November 10, 2022

Subject: Beresford Elementary School HVAC Replacement
San Mateo - Foster City School District
Aedis Project No. 2021011.04
DSA Application #01-120124

ADDENDUM NO. 1

AD1-
A1.01

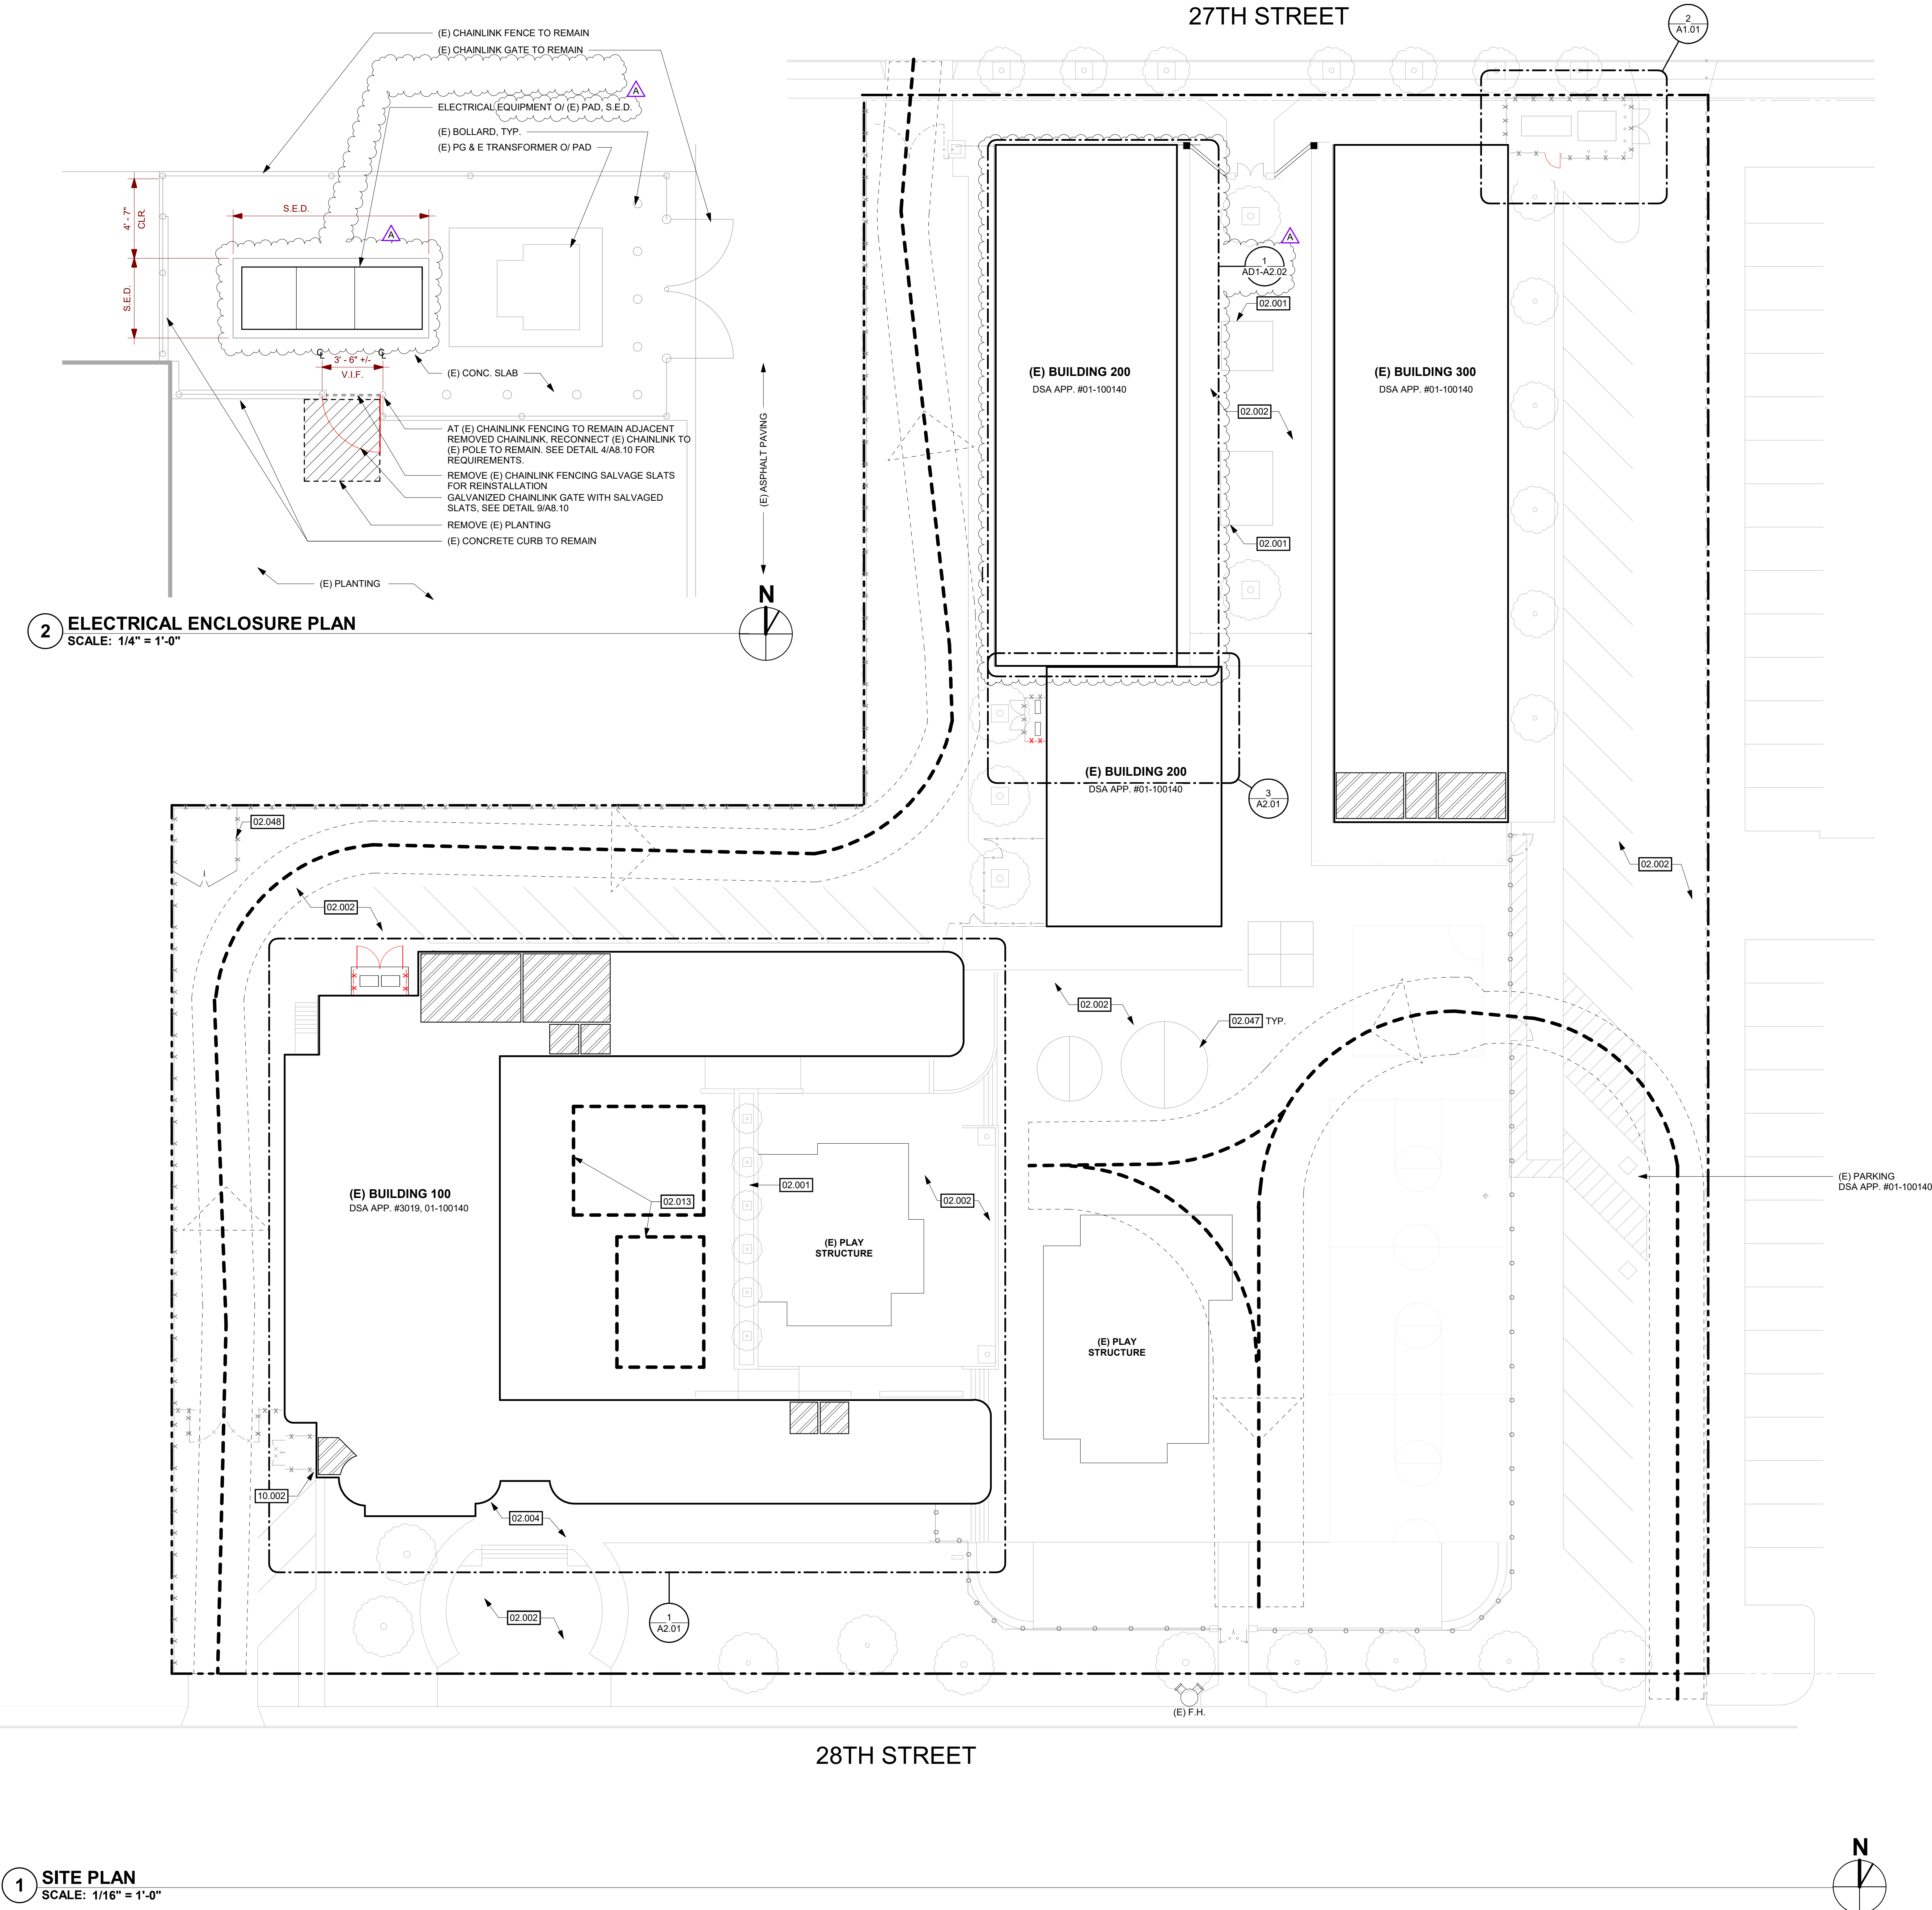
ITEM NO. 1.3: DRAWING SHEET A1.01 – SITE PLAN

Add: Partial Floor Plan callout at building 200 in Site Plan as clouded per AD1-A1.01

Revise: Electrical Enclosure Plan and notes as clouded per AD1-A1.01

9 HEADER AND JAMB CONNECTION

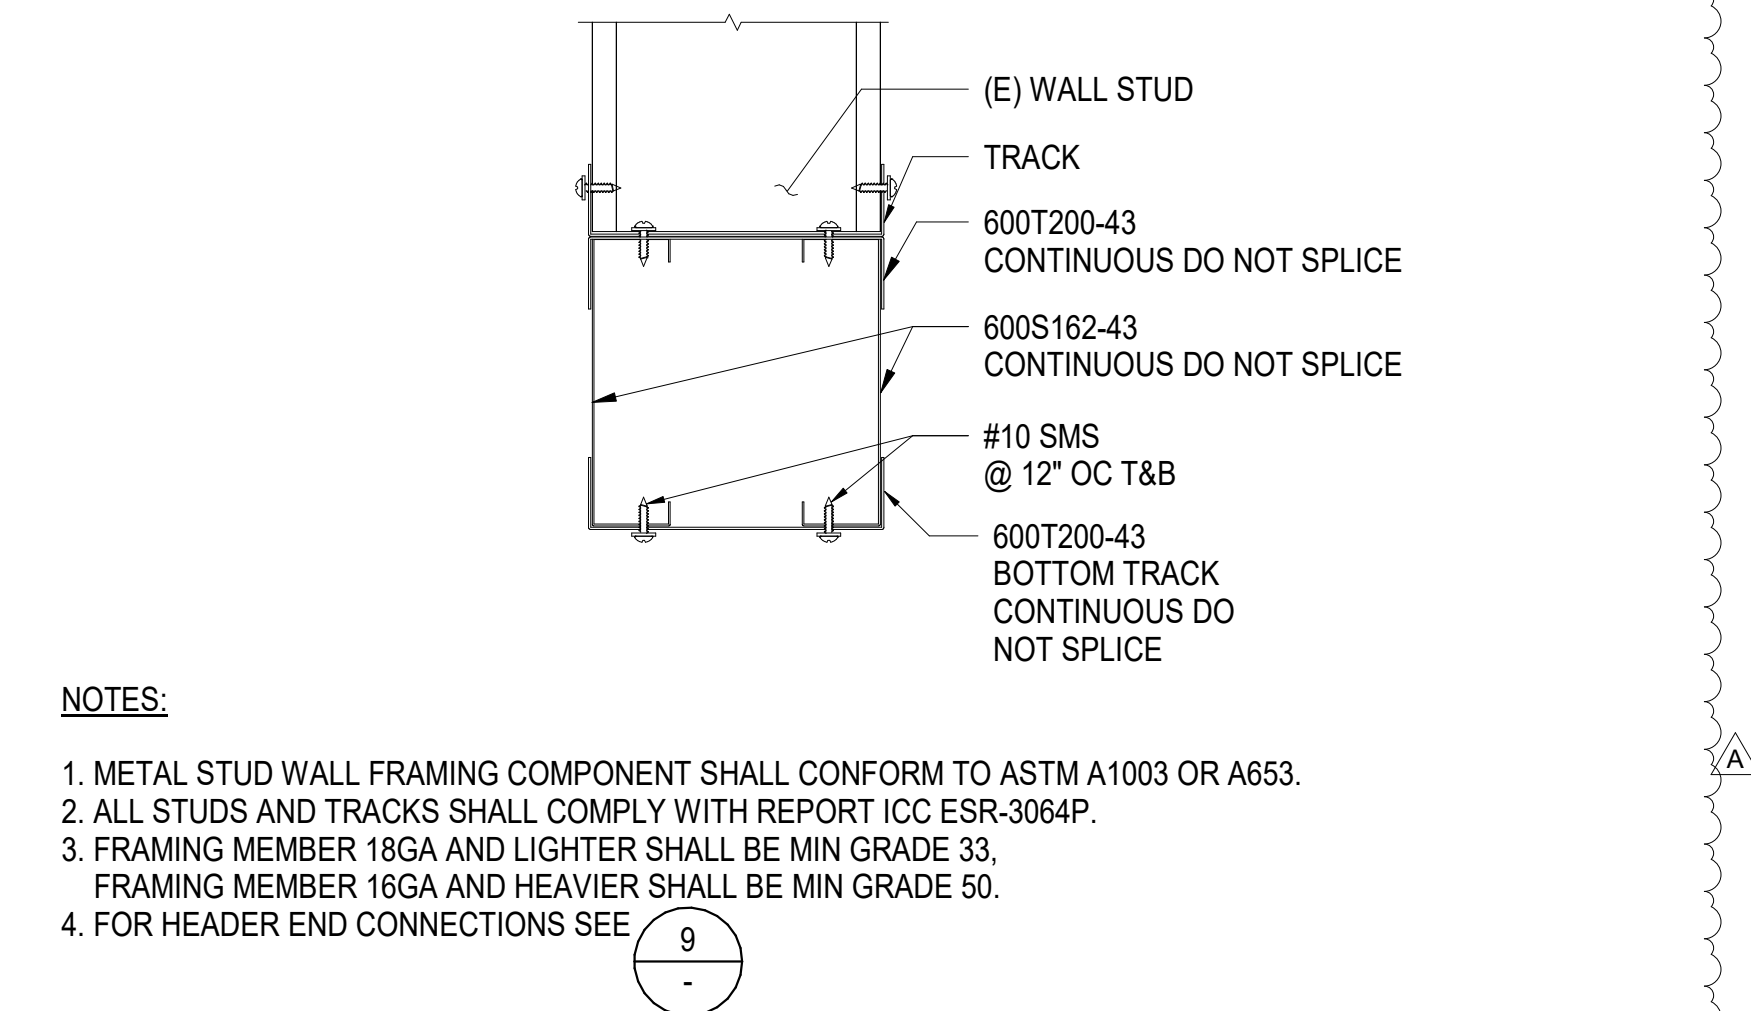
STRUCTURAL**ITEM NO. 1.6: DRAWING SHEET S8.01 – FRAMING DETAILS AND NAILING SCHEDULE**

Add: Details #9 & 10 as clouded per AD1-S8.01

1 **MULTI-PURPOSE BLDG FLOOR PLAN - DEMO - MECHANICAL & PLUMBING**
MP2.01 SCALE: 1/8" = 1'-0"

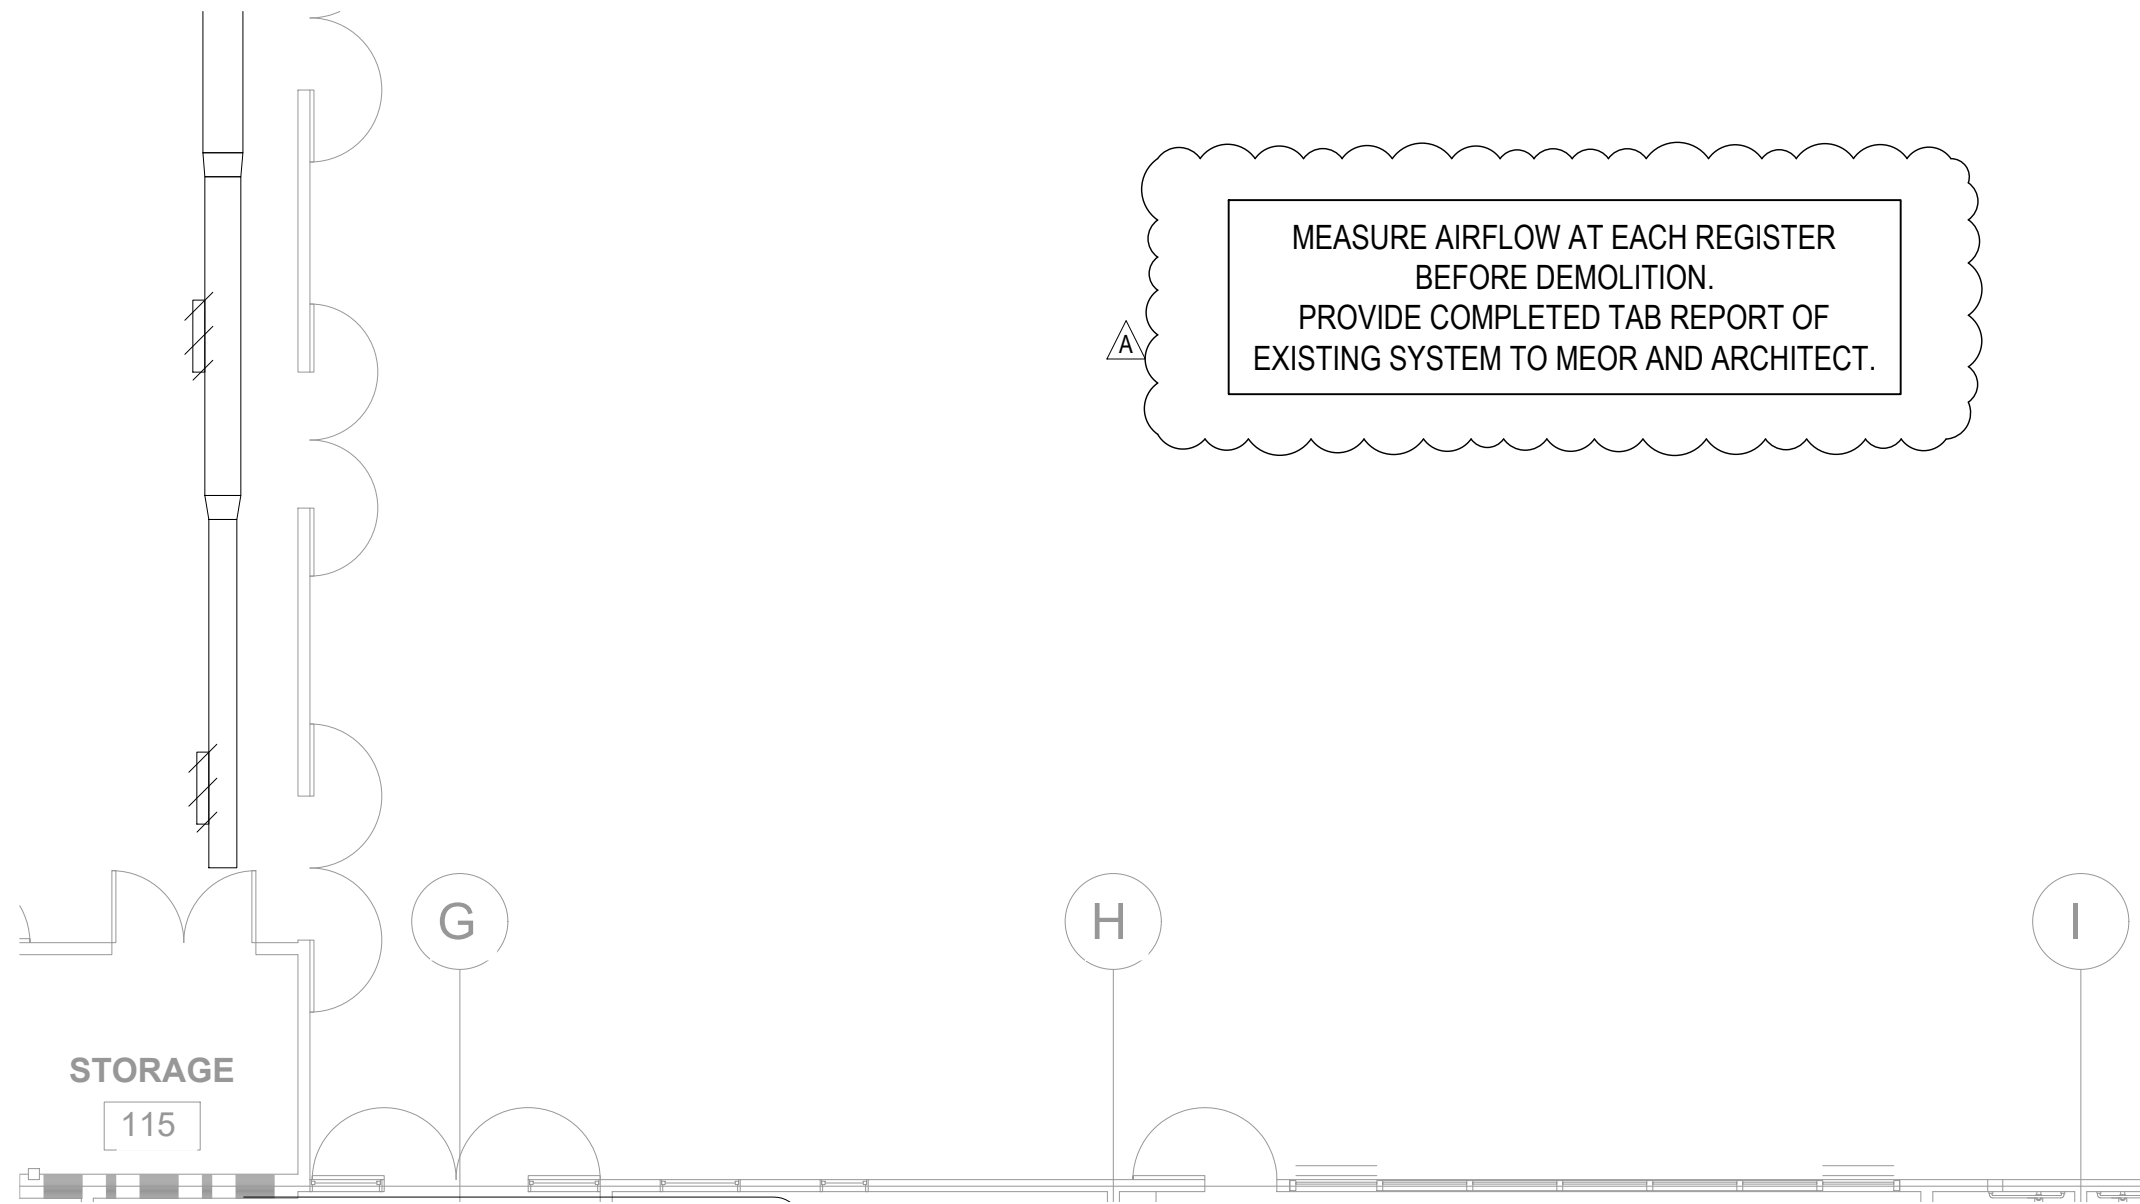
ITEM NO. 1.8: DRAWING SHEET MP2.01 – MULTI-PURPOSE BLDG FLOOR PLAN – DEMOLITION – MECHANICAL & PLUMBING

Add: Multi-Purpose Bldg Floor Plan Demo Mechanical & Plumbing note as clouded per AD1-MP2.01

MODULAR BLDG FLOOR PLAN - DEMO - MECHANICAL & PLUMBING

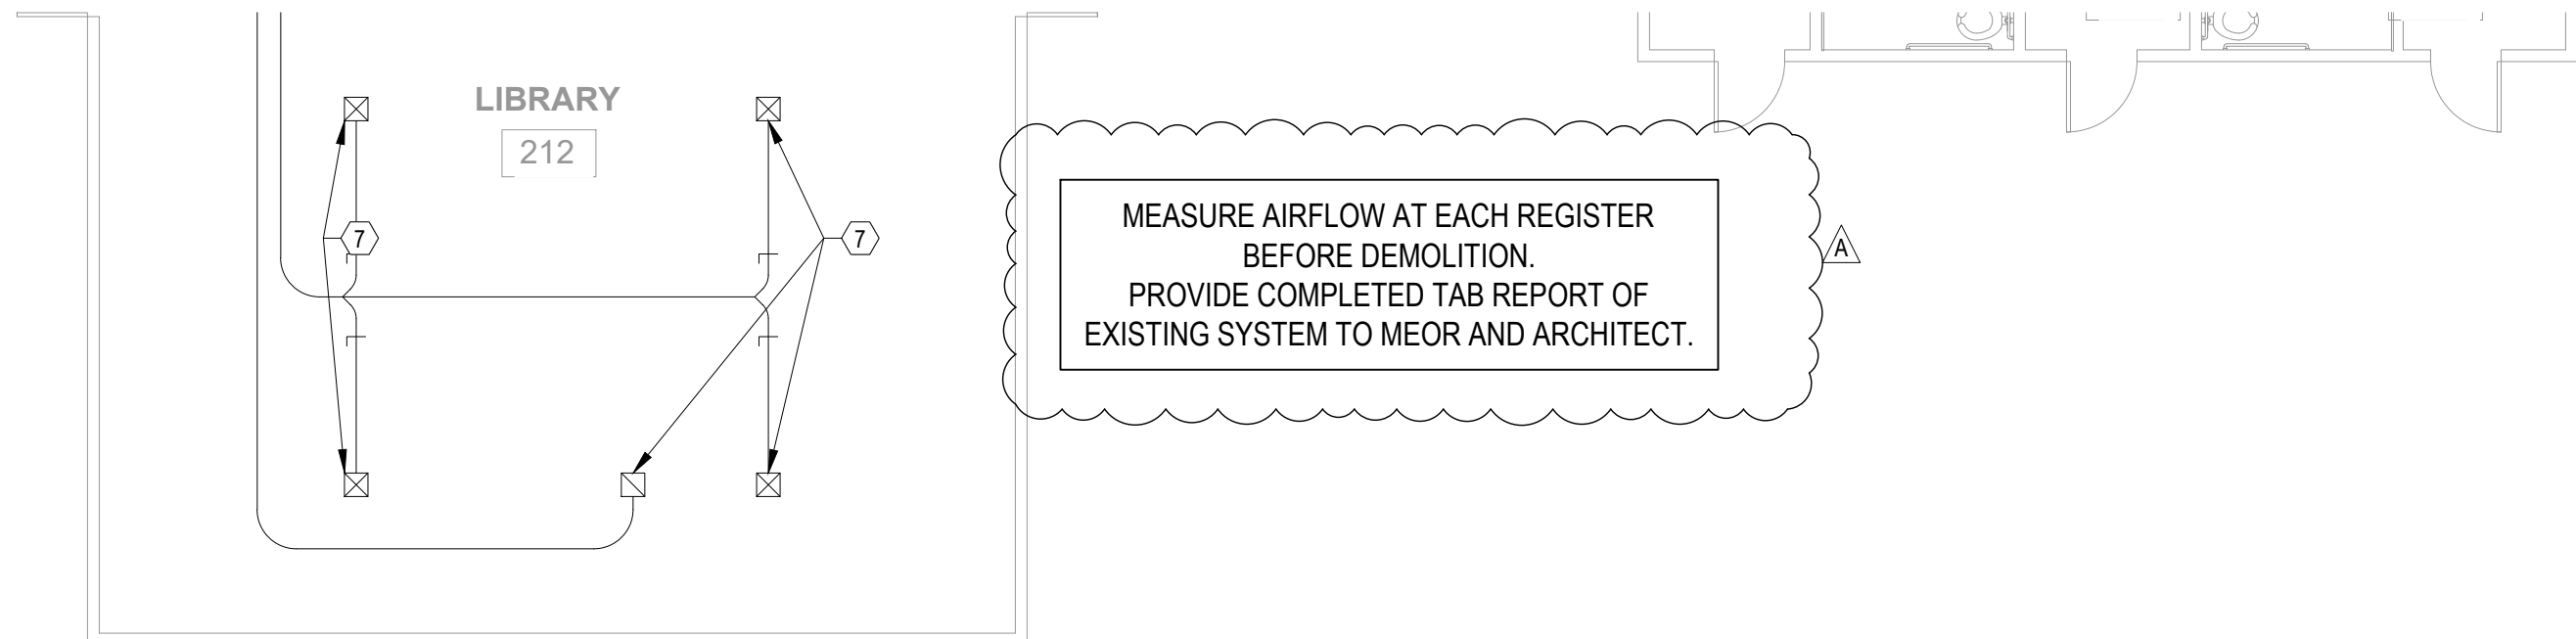
ITEM NO. 1.9: DRAWING SHEET MP2.02 – MODULAR BLDG FLOOR PLAN – DEMOLITION – MECHANICAL & PLUMBING

Add: Modular Bldg Floor Plan Demo Mechanical & Plumbing note as clouded per AD1-MP2.02

Revise: Demolition Sheet Note #2 as clouded per AD1-MP2.02
